Knit Plus Limited (Unit-2)

Jahar Chnada, Belma, Ashulia, Savar.

09 December 2024 & 29 December 2024

Structural Inspection Report

Observation 5: Crack observed at connecting bridge area (Building-2-Office building).

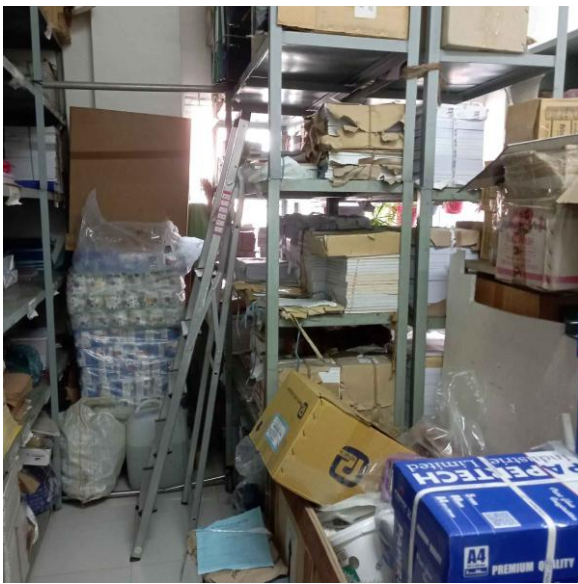
Description: A connecting bridge was observed between Building 2 and the adjacent structure. However, a crack was observed on the slab of the connecting bridge at the Building-2 side. The building engineer is required to investigate the cracked area and prepare an investigation report. Also, prepare an assessment report on the bridge connecting as per onsite conditions. Implement remediation work accordingly.

17.	Crack was observed at the connecting bridge area (Building-2-Office building).	The building engineer is required to investigate the cracked area and prepare an investigation report. Also, prepare an assessment report on the bridge connecting as per onsite conditions.	within 6 weeks

18.		Implement remediation work accordingly.	within 6 months
19.	Column plaster damage due to trolley impact (Building-2-Office building).	The building engineer is required to repair the plaster and provide a column guard to prevent trolley impact.	within 6 weeks

Observation 17: Lack of design documents. (Building 10- Old ETP Building).

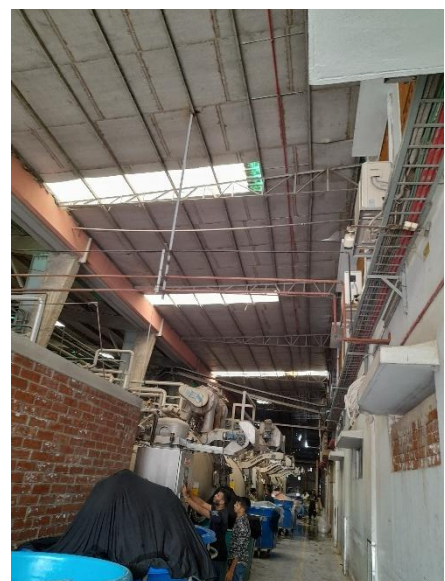
Description: As per BNBC, every building or structure designed shall have its design documents prepared by the provision of Section 1.9.1. The design document shall include a design report, and a set of structural drawings, which shall be prepared in compliance with section 1.9.1.1 and section 1.9.1.2 as per BNBC. At the time of inspection, the design report and structural drawing were unavailable. Also, no load plan or test report (geotechnical investigation report/cylinder test report/rebar test report) was available. The building engineer is required to prepare a load plan, and geotechnical investigation report, verify concrete strength by taking 4 (minimum) cores from the column, and prepare a Detailed Engineering Assessment (DEA).

55.		Implement remediation work if required.	within 6 months
56.		Implement the floor load management program	within 6 months
57.	Lack of design documents. (Building 10- Old ETP Building).	The building engineer is required to prepare a Detailed Engineering Assessment (DEA) and submit it to RSC for review.	within 6 weeks

Observation 29: Lack of lateral stability and absence of design documents (Shed- 9)

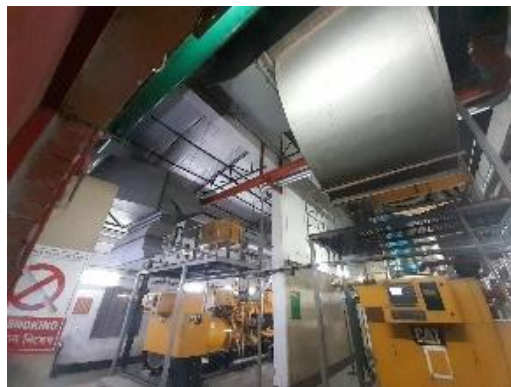
Description: During the inspection, it was observed that Shed 9 is partially connected with Shed 7. However, no lateral load transfer mechanism is provided to adequately transfer lateral loads between the sheds. Additionally, a bracing system is absent in the structure, which raises concerns about lateral stability. Also, as per BNBC, every building or structure designed shall have its design documents prepared following the provision of Section 1.9.1. The design document shall include a design report, and a set of structural drawings, which shall be prepared in compliance with section 1.9.1.1 and section 1.9.1.2 as per BNBC. During the inspection, neither the design report nor the as-built drawings were available for review. The building engineer must verify the lateral stability of Shed 9 and Shed 7 and prepare the design report and as-built drawing in compliance with section 1.9.1 (Part 6, BNBC).

96.	Lack of lateral stability and absence of design documents (Shed- 9)	The building engineer must verify the lateral stability of Shed 9 and Shed 7 and prepare the design report and as-built drawing in compliance with section 1.9.1 (Part 6, BNBC).	within 6 weeks
